# **Transportation Impact Study - Addendum**

# **PROPOSED RESIDENTIAL SUBDIVISION DEVELOPMENT**

Second Submission: April 25, 2019  
First Submission: January 23, 2018  
Project No: NT-17-217

**Re: Transportation Impact Study  
Belfountain Residential Subdivision  
Our Project No. NT-17-217**

Figure 4-1 – Site Generated Traffic Assignments

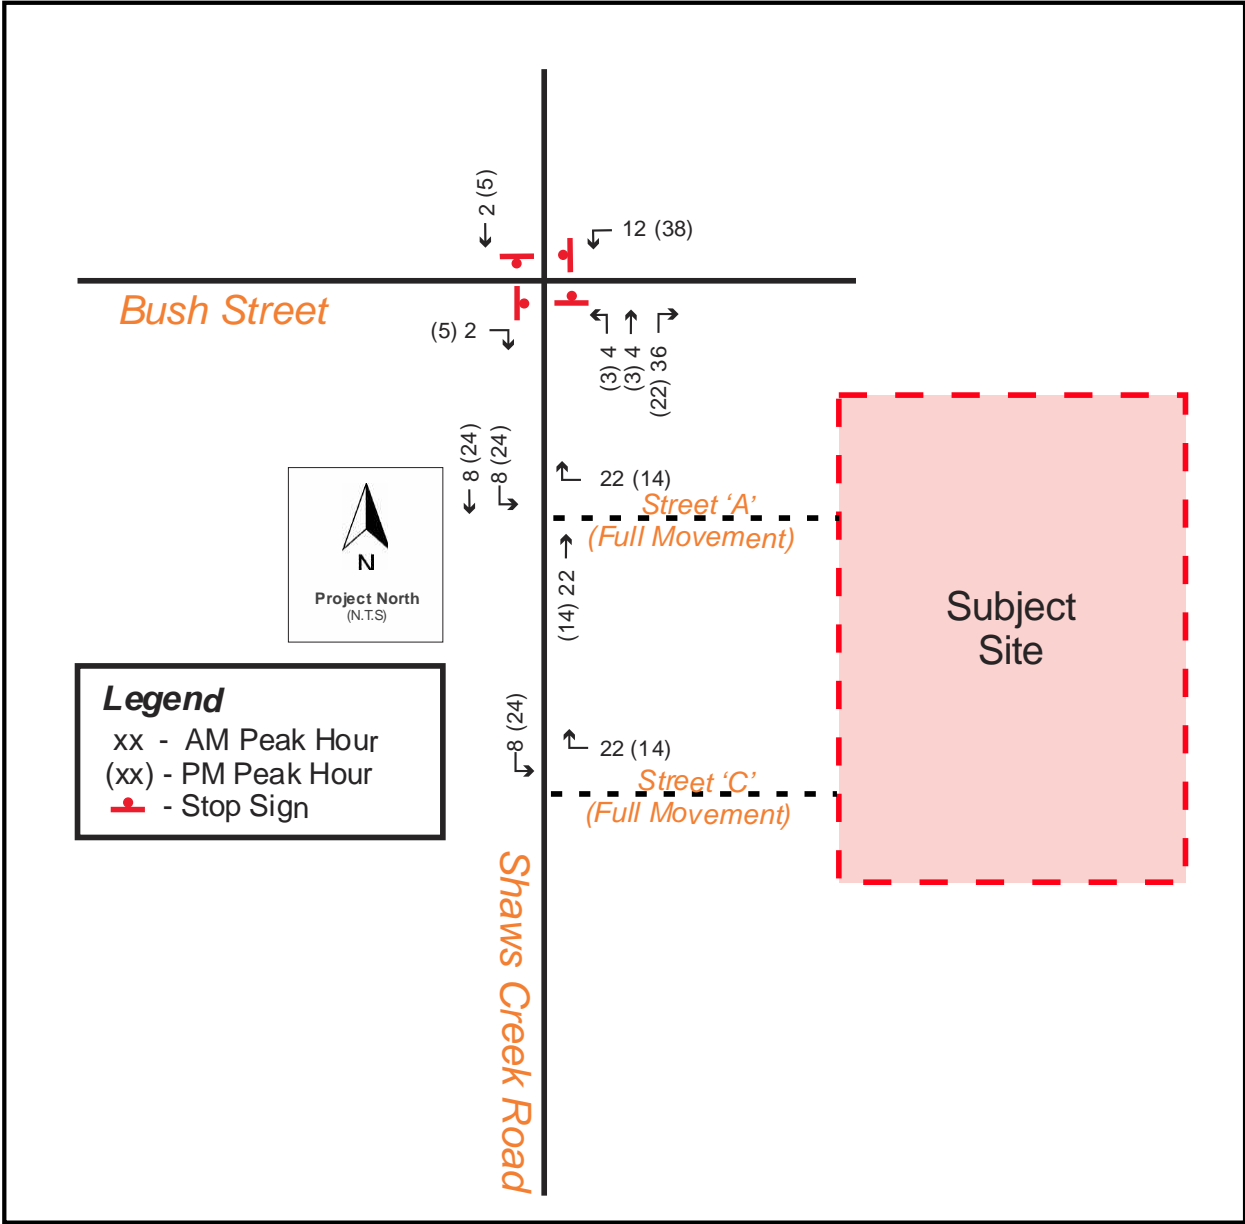
6. Trip distribution: the report assumes that traffic will be going south on Shaws Creek Road to The Grange Sideroad. If Shaws Creek is not paved beyond the subdivision, would the traffic more likely go north through the village to Mississauga Road resulting in the need to widen Bush Street?

**Response:** As per conversation with City staff, the road paving on Shaws Creek Road south of the subject site limit may proceed. The site traffic has been reassigned to go northbound on Shaws Creek Road through the village to Mississauga Road. The sensitivity analysis is provided in the second submission. The results do not require a road widening for Bush Street.

Figure 9.1 Pedestrian Circulation Plan

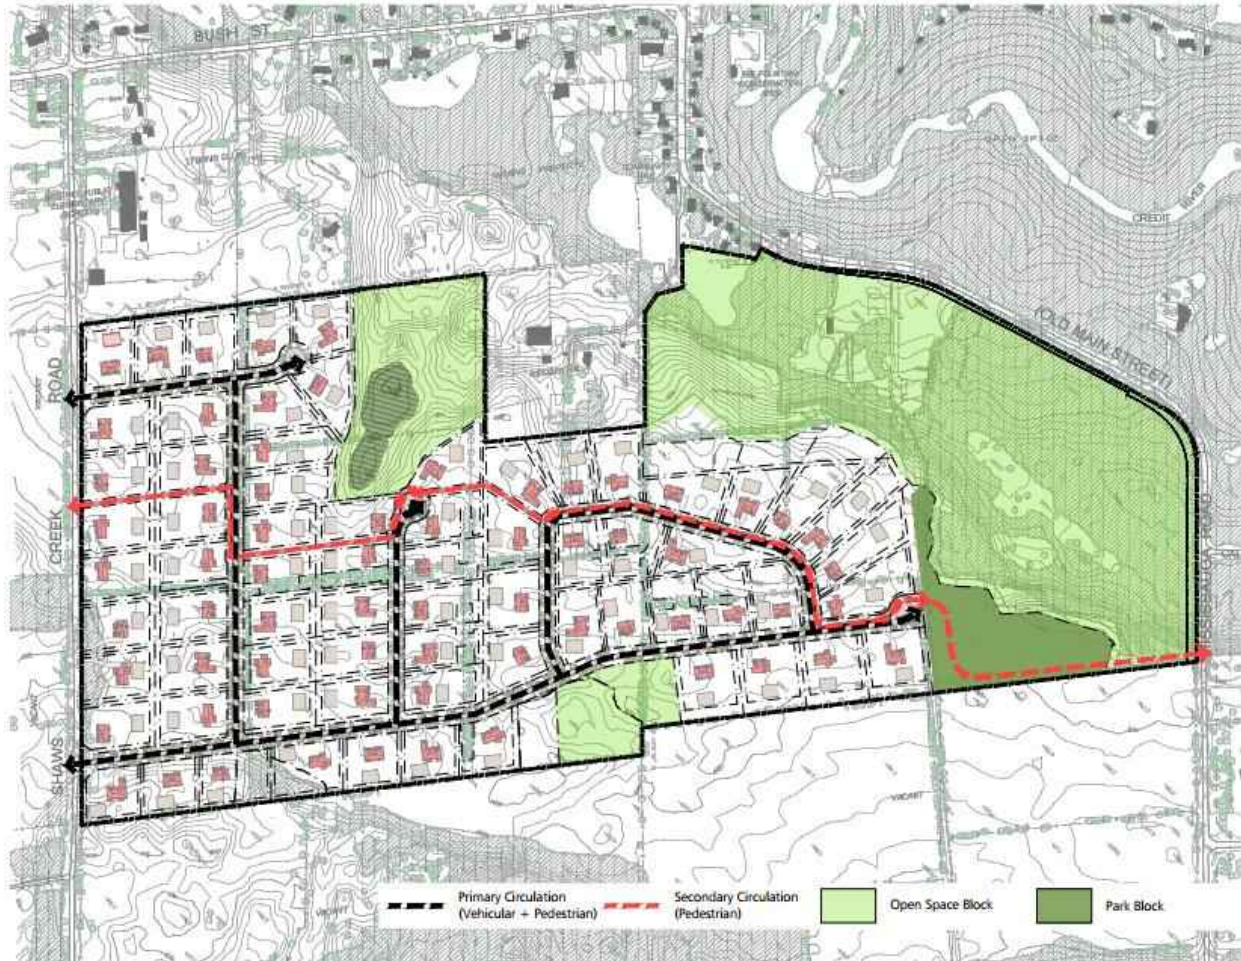
9. Pedestrian circulation: the report proposes a footpath through the Escarpment Natural Area to Old Main Street. NEC staff is concerned about the impact of such path on the natural environment. If this path is not allowed, did the consultant consider other means of active transportation to allow residents of the proposed subdivision to get to the village? (e.g. cycling routes – need for bike lane on Shaws Creek Road).

**Response:** Acknowledged and addressed in **Section 10.0**.

DESIGN BY: A.S.	DATE: April 12, 2019
CHECKED BY: R.P.	PROJECT NO.
DRAWN BY: A.S.	NT-17-217
SCALE: NTS	DRAWING NO. Figure 7-1

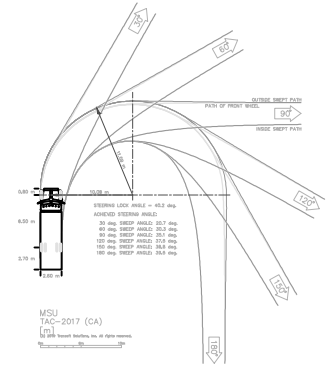
8. Site Plan Review: the report concludes that a large vehicle could navigate the proposed streets. Did this analysis consider the terminus of Street C? Could a large vehicle turn around in the cul de sac without having to back up? Will there be a barrier at the end of Street C or is vehicle access to the park proposed?

3. Road layouts shall be designed to permit a waste collection vehicle to drive forward without reversing for waste collection. Where the requirements for a road layout permitting forward movement of a waste collection vehicle cannot be met, a cul-de-sac or a T-turnaround shall be provided in accordance with the specifications shown in Appendices 2 and 3, respectively (Waste Collection Design Standards Manual).

**Response:** The AutoTURN analysis demonstrates that the waste collection vehicle can turn around in the cul de sac without reversing per the Waste Collection Design Standards Manual and Region Design Standards. A barrier will be provided at the end of Street C. There will be no vehicle access to the proposed park.

**Response:** The AutoTURN demonstrates that the waste collection vehicle does not need to reverse for collection.

**DEVELOPMENT CONCEPT PLAN  
MANORS OF BELFOUNTAIN CORP**

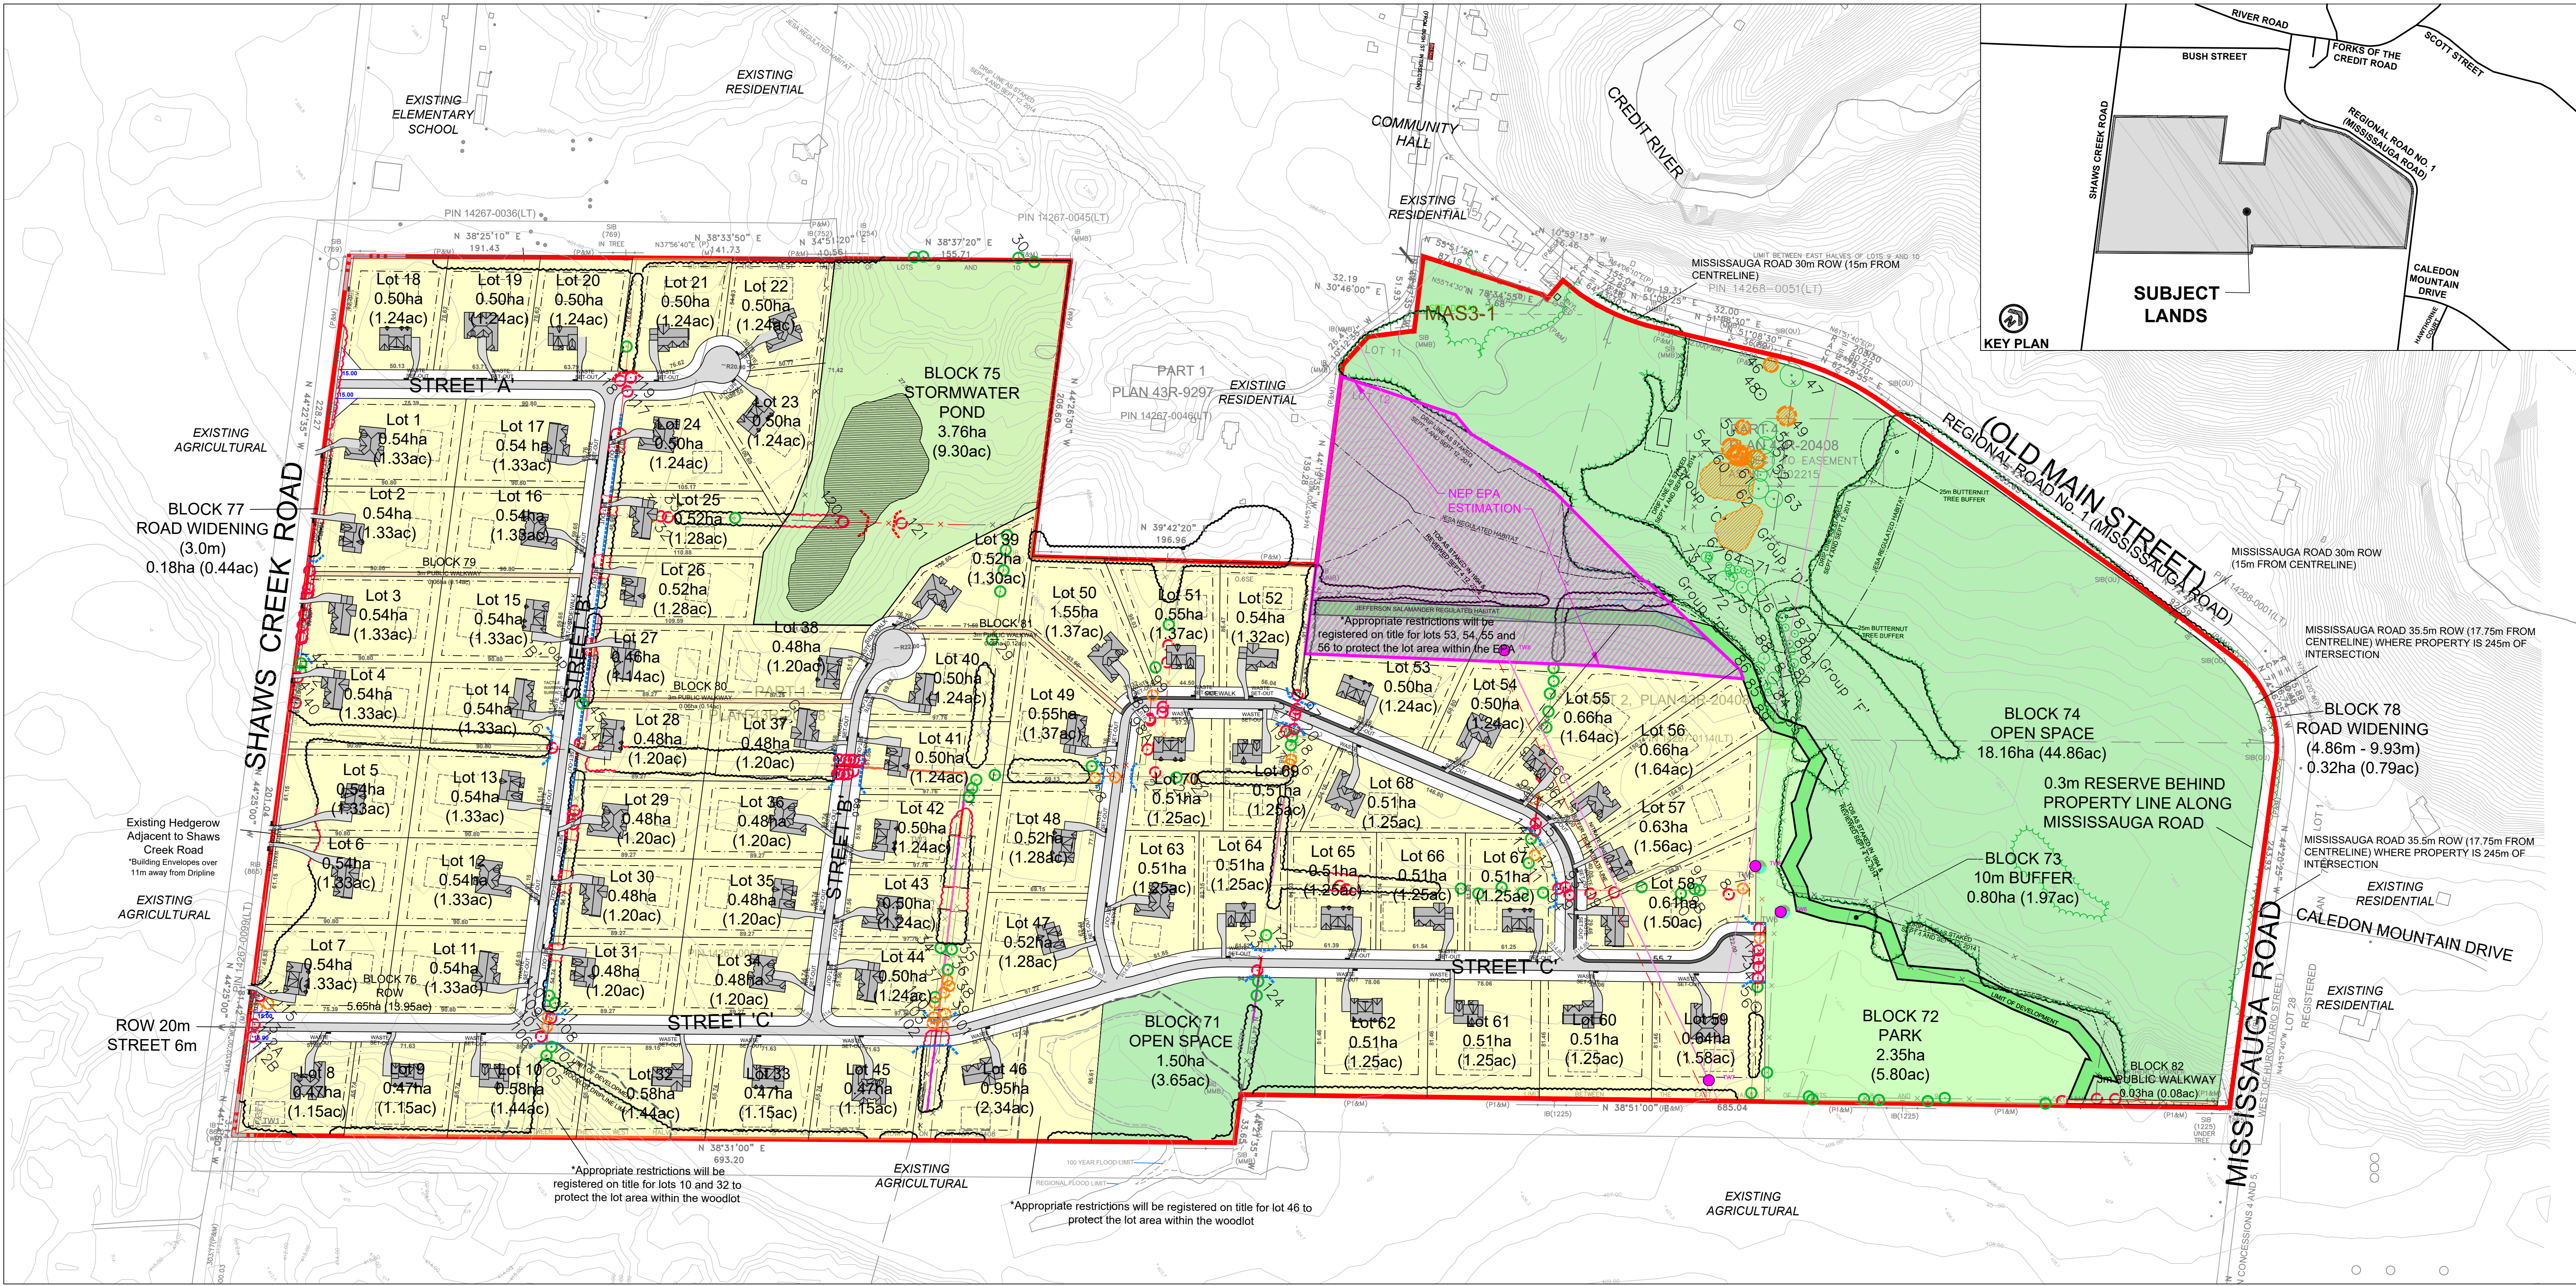
4. The turning radius from the centre line must be a minimum of 13 metres on all turns. This includes the turning radii to the entrance and exit of the site. Please show and label the turning radii in subsequent submissions.

5. The proposed cul-de-sac on the East side of the site by Lot 55 and Lot 56 must have a minimum 13 metre turning radius from the centre line. Please show and label the turning radius from the centre line in subsequent submissions.

**Response:** Requirement met. Refer to draft plan.

**Response:** Requirement met. Refer to draft plan.
